STAFF RECOMMENDATION
1405 Russell Street
July 17, 2019

Application: New Construction—Addition; Partial Demolition
District: Lockeland Springs-East End Neighborhood Conservation Zoning Overlay
Council District: 06
Base Zoning: R6
Map and Parcel Number: 08313027500
Applicant: Cheyenne Smith
Project Lead: Melissa Baldock, melissa.baldock@nashville.gov

Description of Project: Application is to construct a rear addition that extends wider than the historic house and more than doubles the footprint of the historic house. The project involves removing non-contributing extensions at the rear.

Figure 2 (left) is the enclosed porch that is to be removed at the rear. Also visible is the rear deck that will be removed. Figure 3 is the 1957 Sanborn map that shows the rear porch extension.

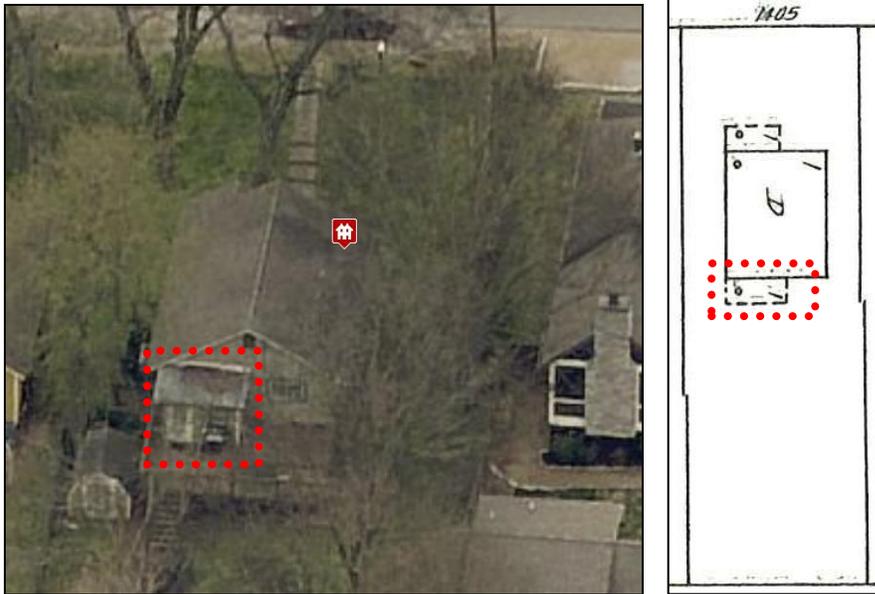
Demolition: The applicant proposes to demolish a frame portion at the rear of the house (Figure 2). The 1957 Sanborn map shows an enclosed porch at the rear of the home. Although part of this addition may be original to the house, staff finds that it does not contribute to the historic character of the house or the district for several reasons. Enclosed porches like this one were often constructed with lighter materials and framing so that after eighty-some years, they are often either structurally unsound or have been reconstructed already. In addition, this porch is located at the rear of the house, where it is not highly visible from the street. Its location, lack of a proper foundation, and low shed roof form that is separate from the house, all combine to make the rear porch non-contributing. The applicant also intends to remove the uncovered deck, which is not something that is reviewed by MHZC in a conservation overlay like Lockeland Springs-East End.

Staff finds that the proposed demolition meets Section III.B.2 for appropriate demolition and does not meet section III.B.1 for inappropriate demolition

1 FLOOR PLAN

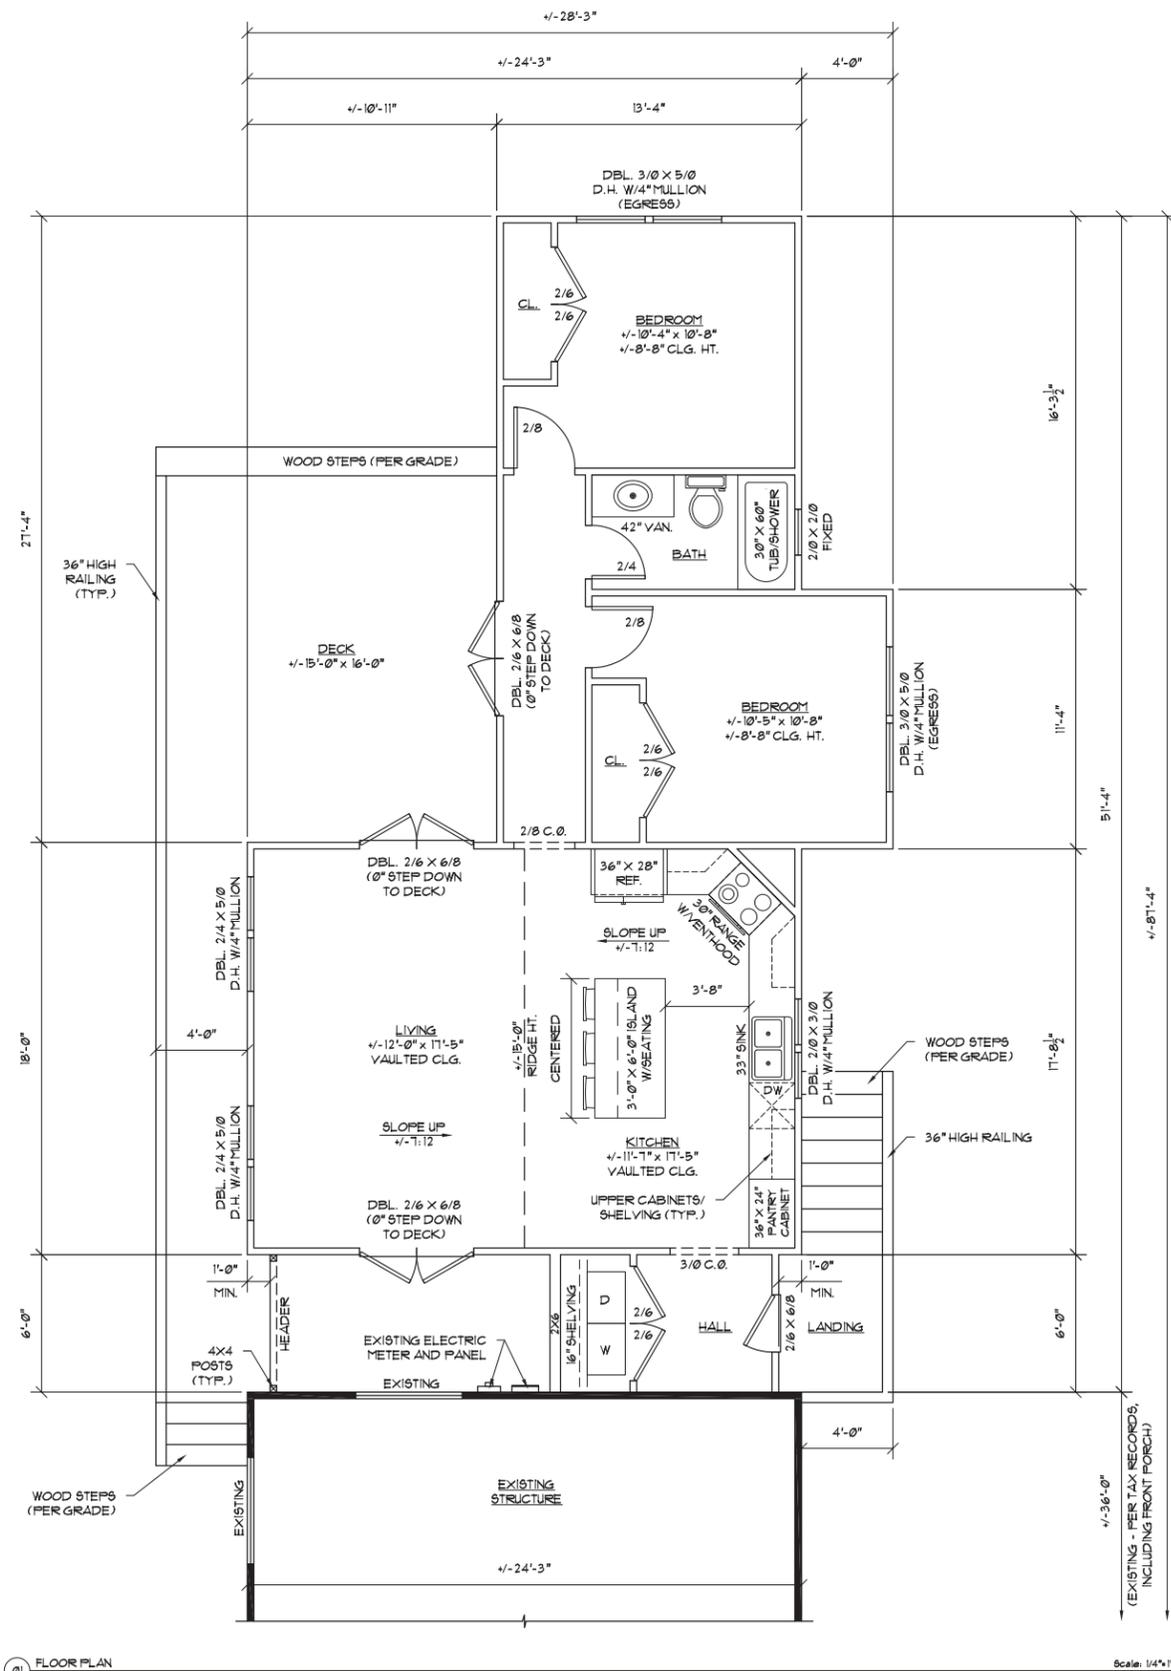
The addition is inset appropriately. On the left side, the addition is inset thirteen feet (13') for a depth of six feet (6'). After this depth, the addition steps back out to match the line of the historic house. On the right side, the addition is inset one foot (1') for a depth of six feet (6'). After that depth, the addition steps back out to match the line of the historic house. Further back at a point over twenty-three feet (23') back from the back corner of the historic house, the addition extends four feet (4') wider than the historic house for a depth of eleven feet, four inches (11'4"). Staff finds this wider portion of the addition to be appropriate for several reasons. First, the historic house is incredibly narrow at just twenty-four feet (24') and wider additions are allowed under the design guidelines when the historic house is less than thirty (30') wide. In addition, the wider portion of the addition does not occur until it is over twenty feet (20') back from the historic house, lessening its visibility from the street. Lastly, the wider portion of the addition is scaled appropriately; it is over three feet (3') shorter than the historic house, is only six feet (6') wide, and has a side gabled roof form.

Typically the design guidelines requires that additions no more than double the footprint of this historic house. In this case, the historic house has a footprint of eight hundred and sixty-six square feet (866 sq. ft.), whereas the proposed addition has a footprint of

approximately nine hundred and fifteen square feet (915 sq. ft.). Staff finds that the larger footprint is appropriate, in this instance, for a couple of reasons. First, at under one thousand square feet (1000 sq. ft.) in footprint and just one story in height, the historic house is quite small. In the past, the Commission has allowed for additions with slightly larger footprints when one-story houses have been under one thousand square feet (1000 sq. ft.). Second, the addition is a true one-story addition, which helps to keep its scale in keeping with the historic house. The addition will be no taller than the historic house. Because the addition is otherwise modestly scaled, staff finds the proposed footprint to be appropriate.

Location & Removability: The location of the addition at the rear of the existing building is in accordance with the design guidelines. The addition has a minimal ten foot (10') wide connector that is five feet (5') lower in height than the historic house, which means that if the addition were to be removed in the future, the main form and character of the historic house would remain intact.

02 LEFT ELEVATION (WEST)

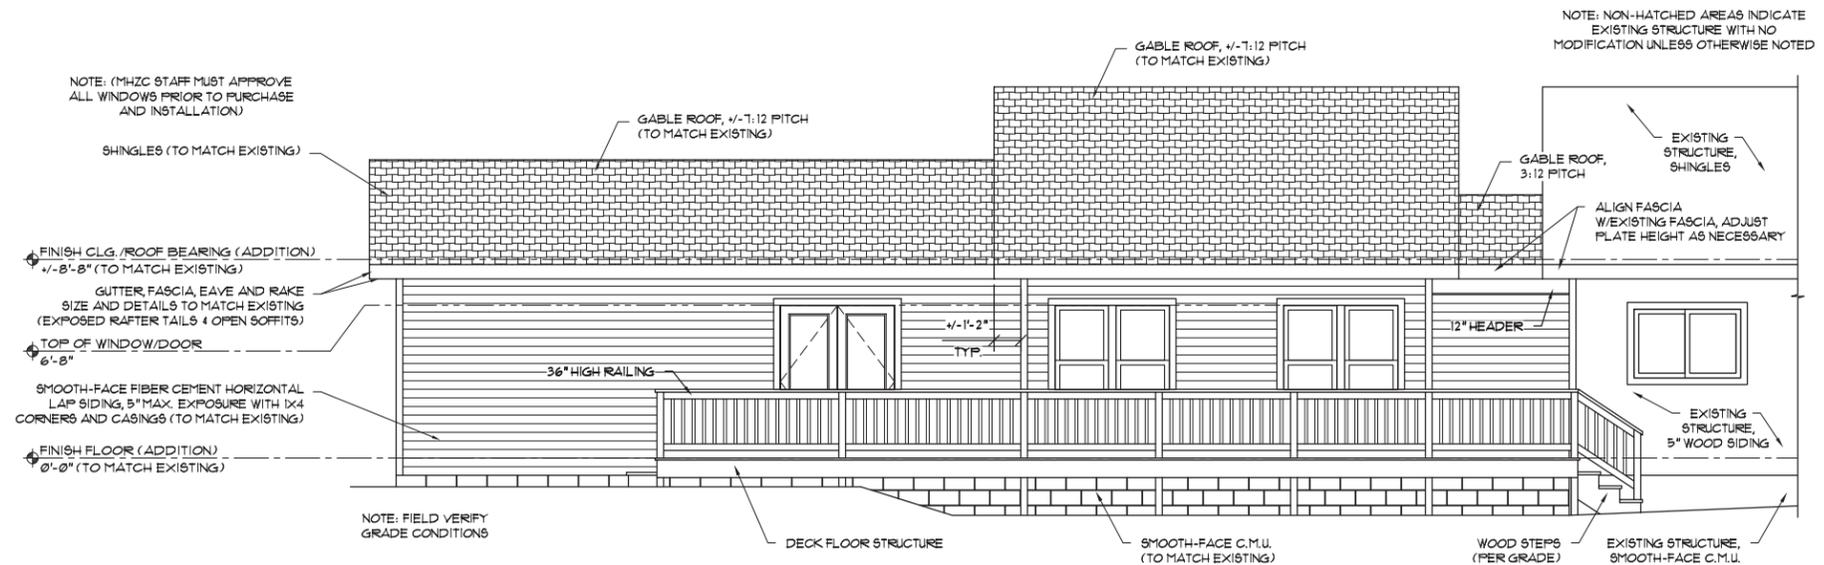
Proportion and Rhythm of Openings: No changes to the window and door openings on the existing house were indicated on the plans. The windows on the proposed addition are all generally twice as tall as they are wide, thereby meeting the historic proportions of openings. There is one sixteen foot (16') long expanse of wall space without a window or door opening on the left façade, but staff finds this to be acceptable because it is over

thirty-feet back from the back of the historic house and will not be highly visible from the street.
